Addendum No. 1

Project: **Dental Clinic**

Date: <u>11-04-2019</u>

All bidders are herewith notified of the following additions, deletions, changes or clarifications to the drawings dated 10-28-2019 and shall be acknowledged as received on the proposal.

**SA01**

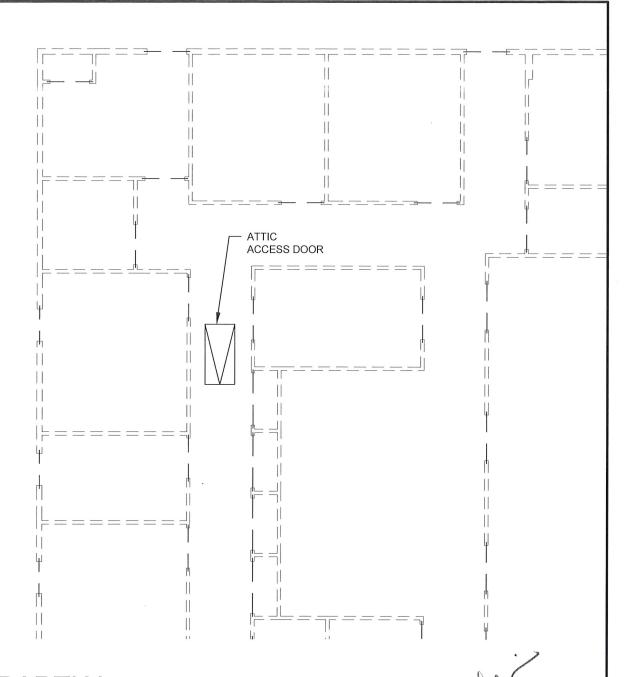
- b. Ceiling Joist Framing Plan shows framing of barrel vault ceiling at Waiting Area-100, Ref. SA01, SA02 and SA03.
- 6. Structural S4:
  - a. Relocate Attic Access Door to location in front of break room. Reference Architectural RCP.

**SA03**

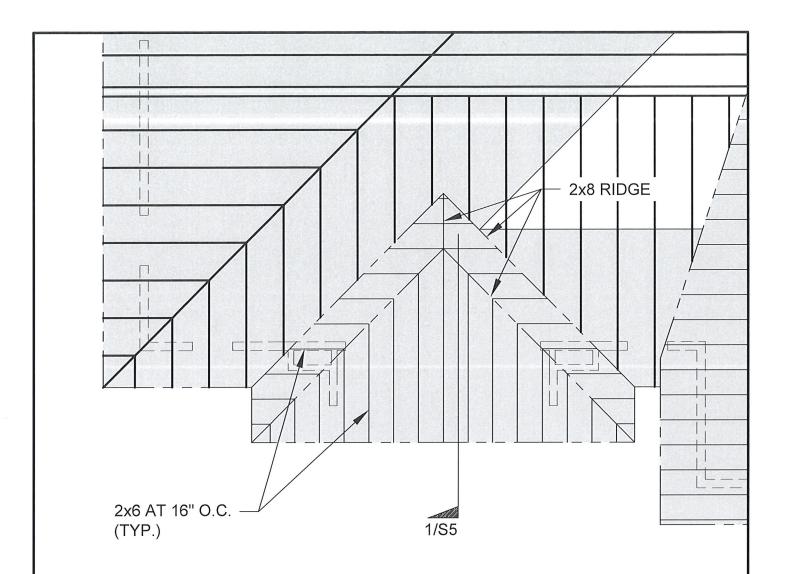
- b. Modify roof framing members as shown.
